RE: Bass 7 Federal #1 ✓  
LC-060572-A  
NE SW Section 7 T21S, R28E  
Eddy County, New Mexico

**SUNDRY NOTICES AND REPORTS ON WELLS**

# BASS 7 FEDERAL # 1 WELL DIAGRAM

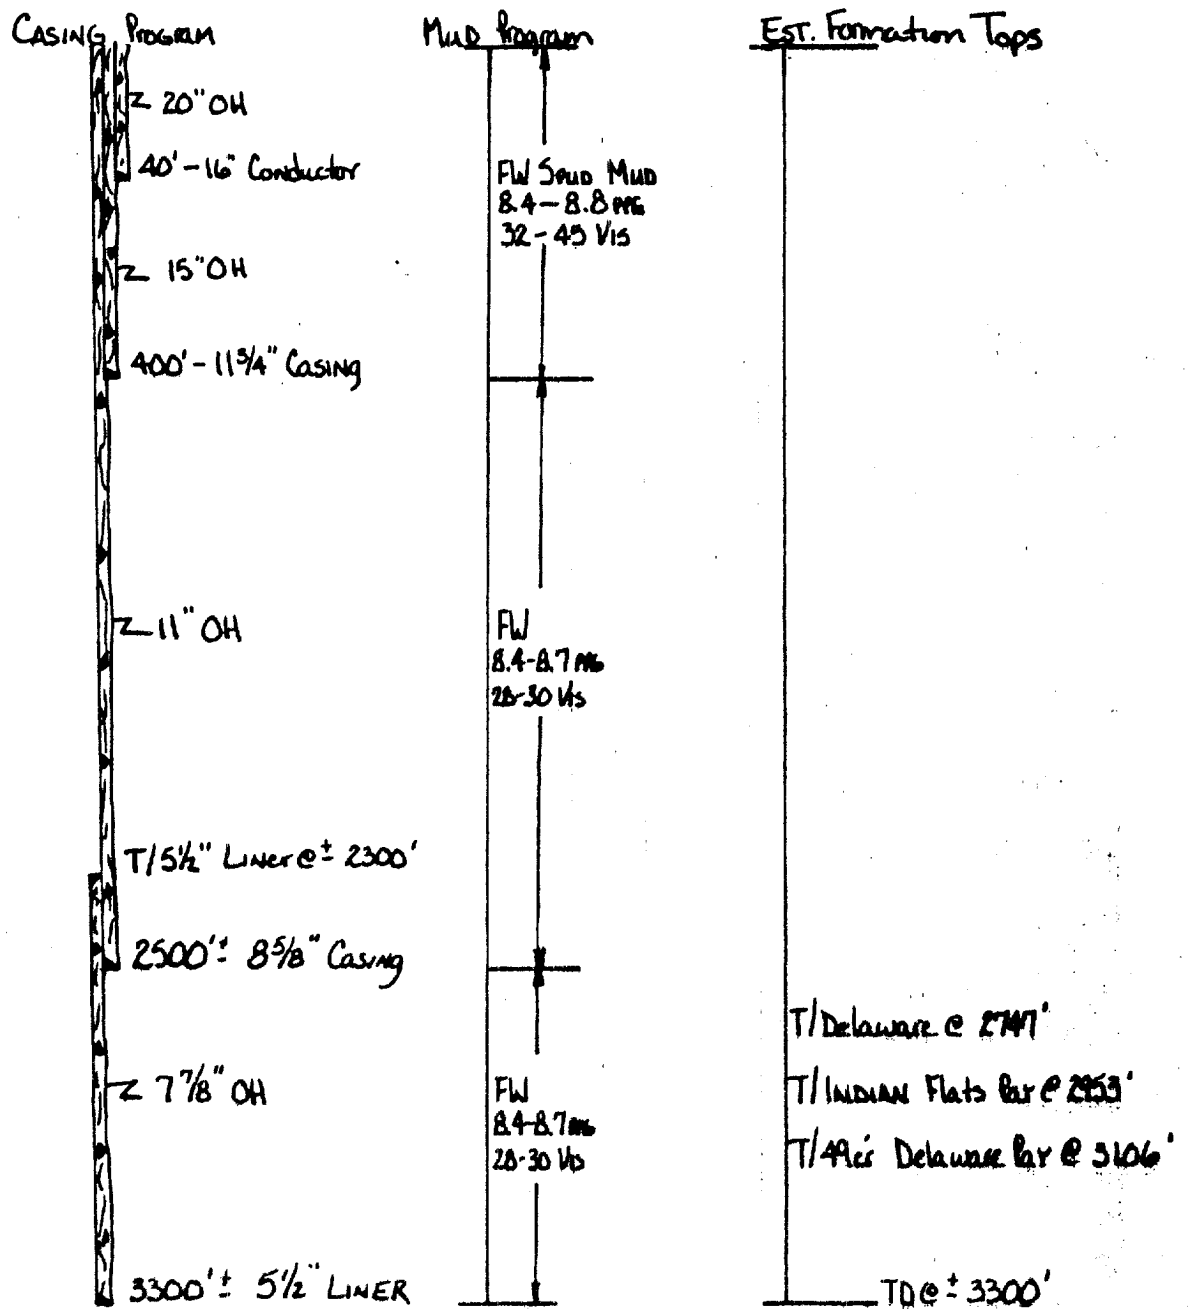
Please find the attached Sundry Notice form 9-331 along with a revised well diagram sketch for our Bass 7 Federal #1 location. The change in the casing program is to comply with New Mexico State Rules (Order #63) concerning underground waters. The lease name has also been changed from Bass Federal 7 #1 to Bass 7 Federal #1.

NOTE: Cement to be circulated on 8 5/8" Casing to comply with NM State Rules (Order #63).

SIZE OF HOLE	SIZE OF CASING	WEIGHT PER FOOT	SETTING DEPTH	QUANTITY OF CEMENT
20"	16" Conductor	--	40'±	Cir. to Surface (Ready-mix)
15"	11-3/4"	42	400'±	Cir to Surface
11"	8-5/8"	24	2500'±	Cir to Surface
*7-7/8"	5-1/2" Liner	14	3300'±	250 sxs Cmt.

\*Note: 5 1/2" liner to have a 200'± overlap.
